# **Report on Indiana Michigan Power Company's 2021 Integrated Resource Plan**

**Submitted to the IURC on August 3, 2022**

**On behalf of CAC, Earthjustice, and Vote Solar**

Figure 1. Natural Gas Price Forecast Comparison (\$/MMBtu)

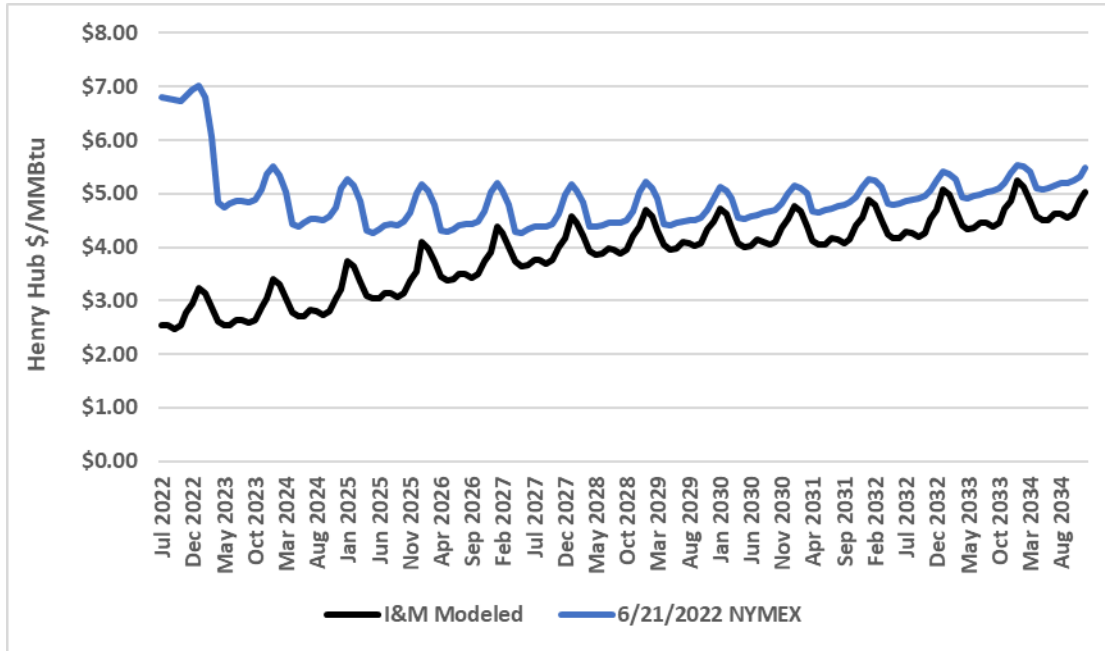
Given the spike in natural gas prices since I&M developed the fuel forecast inputs for its IRP modeling and the large natural gas buildout in I&M's Preferred Portfolio, we request that I&M continue to re-evaluate this resource decision and engage with stakeholders prior to any resource filings. Figure 1 shows the comparison of the natural gas price forecast that I&M modeled for the new thermal resources against the CME/NYMEX futures for gas at the Henry Hub as of June 21, 2022. We assume that the prices I&M modeled are commodity-only prices, but if they also include any transportation costs, then the gap would be larger. The futures are higher than I&M's forecast, but this is not to say that I&M should have or could have used natural gas futures that coincide with or post-date its IRP filing date. As I&M moves forward with any certificate of public convenience and necessity filings or similar approvals, its resource decisions must be reevaluated in light of a myriad of changed circumstances, including natural gas pricing. The recent increases in natural gas prices illustrate the volatility of natural gas pricing, which would be an important consideration to explore as I&M moves forward with the 1,000 MW of CTs in its Preferred Plan.

Figure 8. Modeling of OVEC in Aurora<sup>74</sup>

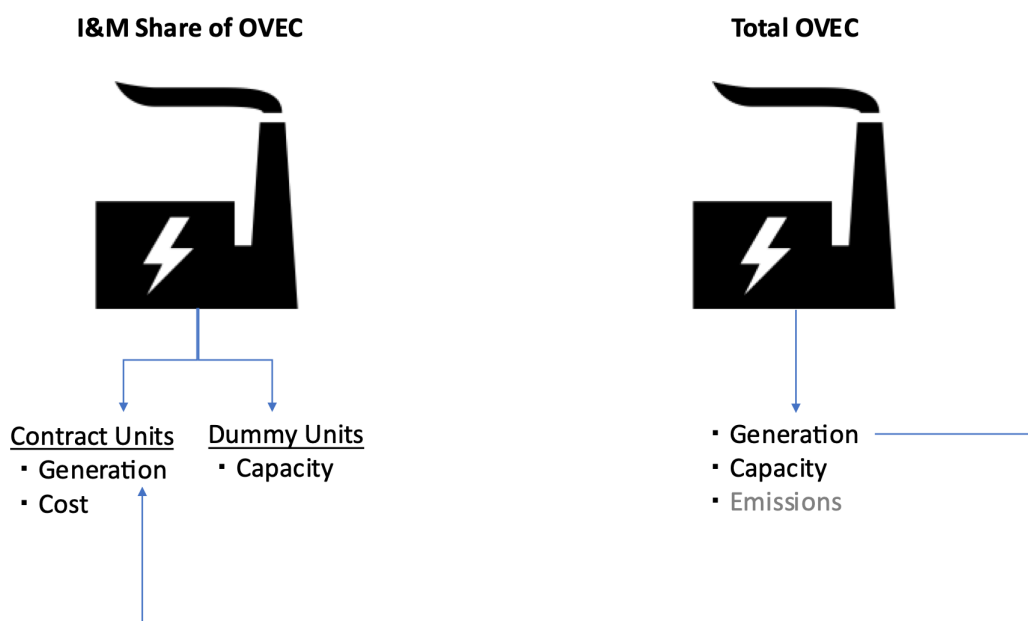
One of the problems with the modeling approach for I&M’s share of the OVEC contract costs is that I&M and Siemens PTI input all Aurora modeling input costs in real 2019 dollars.<sup>75</sup> Aurora then translates the cost *inputs* into nominal modeling *outputs*. In the spreadsheet used to calculate the PVRR of each candidate portfolio, I&M and Siemens PTI then deflated the nominal Aurora outputs back to 2019 real dollars. While this approach of switching between nominal and real dollars is unusual, there is nothing wrong with this approach *per se*. The issue is that Aurora does not permit the use of real dollars in all of the input tables. Aurora’s manual specifically says that the table containing the OVEC contract costs treats all costs as nominal. Even though the OVEC contract costs were seemingly entered in terms of real dollars, they were being treated as nominal inputs by Aurora. As a result, Aurora did not translate the costs into nominal dollars for the reporting of the modeling outputs; it presumed they were already in nominal terms. This creates

a problem for the PVRR calculation since I&M and Siemens PTI treated the ICPA cost outputs as nominal, when in fact they were real. Since the PVRR calculation was premised on the assumption that all outputs were in nominal dollars and I&M and Siemens PTI calculated the PVRR in real 2019 dollars, all outputs including the OVEC energy costs were further deflated for the PVRR calculation. Effectively, it was assumed that OVEC contract costs would decline over time, rather than remaining flat in real terms. Confidential Figure 9 below shows the comparison of the OVEC energy costs (\$/MWh) as they were modeled in Aurora<sup>76</sup> and the costs that should have been modeled<sup>77</sup> in Aurora.
